Item Name: Crosstube Fwd

DART AEROSPACE LTD		Work Order:	87328
Description: Crosstube High Fwd (205/212/412)		Part Number:	D212-664-101
Inspection Dwg: D212-664-141 Rev: D		Page 1 of 1

DRAWING NO. D212-664-141	TITLE XTUBE ASSY (205/212/412 HI FWD)	REV. D	DART AEROSPACE LTD ENGINEERING ORDER		D.E.O. NO. D212-664-141-D-1	SHEET NO. SHEET 1 OF 2	SCALE NTS
DRAWN	CHECKED	MFG. APPR.	APPROVED	DE APPR.			
DATE 11.04.07	DATE 11.07.11	DATE 11.04.12	DATE 11/04/12	DATE 11.04.12

DRAWING NO. D212-664-141	TITLE CROSSTUBE ASS'Y (205 HI FWD)	REV. D	DART AEROSPACE LTD ENGINEERING ORDER		D.E.O. NO. D212-664-141-D-2	SHEET NO. SHEET 1 OF 1	SCALE NTS
DRAWN <i>UP</i>	CHECKED <i>A.S.</i>	MFG. APPR. <i>AB</i>	APPROVED <i>MD</i>		DE APPR. <i>HH</i>		
DATE 11.07.15	DATE 11.07.20	DATE 11.07.21	DATE 11/07/21		DATE 11.07.21

**D212-664-141/-141B
ASSEMBLY DETAIL**

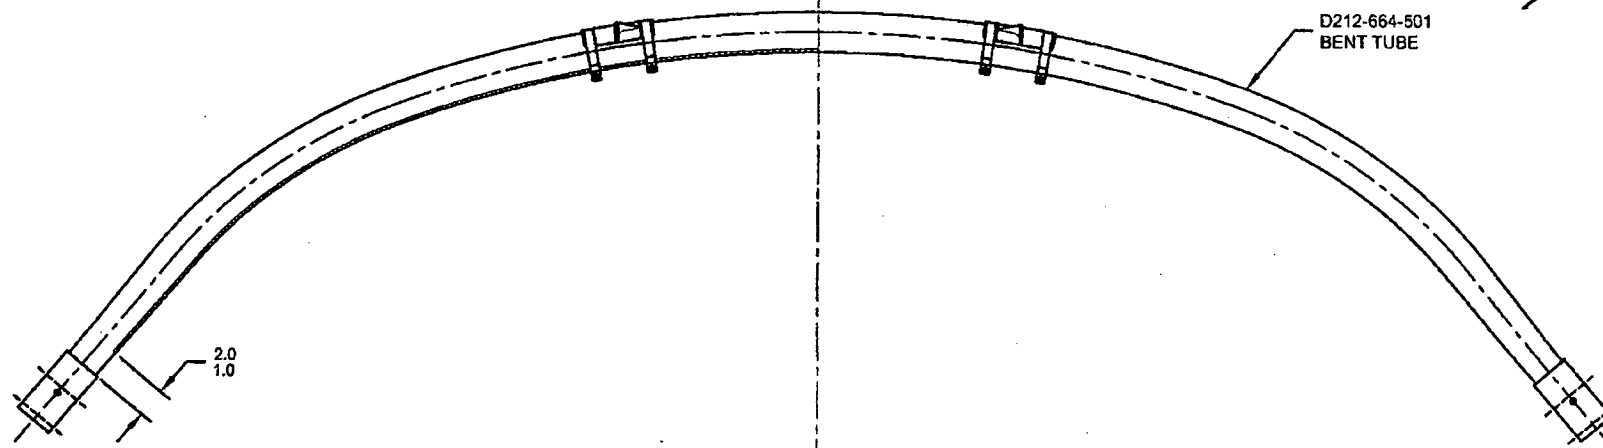
PURPOSE:

ADD AN INSPECTION WINDOW TO UNDERSIDE OF CROSSTUBE.

MASK AREA PRIOR TO PAINTING.
REMOVE MASKING AFTER PAINT
AND APPLY CLEAR COAT

- 2) FINISH: CHEMICAL CONVERSION COAT PER DART QSI 005 4.1
PRIME INSIDE AND OUTSIDE PER DART QSI 005 4.2
MASK UNDERSIDE OF CROSSTUBE AS SHOWN (HATCHED AREA) AND
PAINT OUTSIDE PER DART QSI 005 4.2
REMOVE MASKING AND APPLY CLEAR COAT
